Subject: USNRC 10CFR Part 21 Notification (Log No. 2009-24-00 / Event No. / Accession No. ML093140090) **Revised Notification**

Ref: Flowserve Size 3/4 Figure 848Y Disk/Disk Nut Separation
LaSalle Station
Exelon PowerLabs, LLC Project Number: LAS-62808
Flowserve Complaint Report 4914
Flowserve Evaluation Report No. 10 CFR 21-50

Figure 1 Stem/Disk Assemblies for Old Design and New Design.

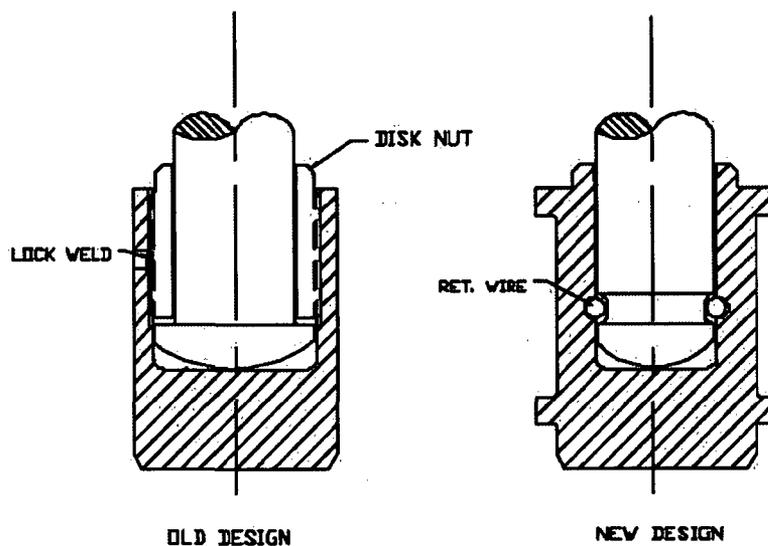
Figure 1 provides an illustration of the stem/disk assembly. The **"Old Design"** is typical of the valve that is the subject of this discussion. The valve stem has a collar on the very end. After the stem is inserted into the disk, the disk nut is threaded into the disk to retain the stem. A lock weld is then created to prevent the disk nut from unthreading out of the disk.

In about 1990, the design was changed to that shown as the **"New Design"** in Figure 1. The disk nut was eliminated, and the disk retained on the end of the valve stem using a piece of wire inserted into a groove located half in the valve stem and half in the disk.

For the case of the **"Old Design"** valve at LaSalle, once the disk nut has unthreaded out of the disk, the stem and the disk are no longer connected. The valve will then operate as a stop-check valve. The valve will open in response to normal forward flow, and close in response to normal reverse flow.

Because the disk nut is a solid piece assembled around the valve stem, the disk nut cannot fall off of the valve stem and become a loose part in the piping system.

After unthreading from the disk, the disk nut will sit on top of the disk. The valve will be able to open only partially, because the disk nut will interfere with the ability of the valve to open fully. The amount that the valve can open will depend on the size of the valve. For the Size 3/4 valve at LaSalle, the disk would be able to open less than 1/8 of an inch. The amount that other valve sizes would be able to open is different, but all would be reduced.

In operation, the valve would function as a stop-check valve rather than a stop valve. If the handwheel is used to close the valve, the valve will remain closed. If the handwheel is used to retract the valve stem, differential pressure in the normal forward flow direction will open the valve and allow flow through the valve.

The valves affected are Size 2 and smaller Edward Figure 848, 849, 828 and 829 valves manufactured by Rockwell International at the Sulphur Springs, Texas, and the Raleigh, North Carolina, manufacturing facilities prior to 1991. These valves may be tagged "Rockwell", "Rockwell Edward" or "Edward". The valves affected have the "**Old Design**" stem/disk assembly shown in Figure 1.

Valves with Figure Number **A848 / A849 / A828 / A829** incorporate the "**New Design**" stem/disk connection and are not affected.
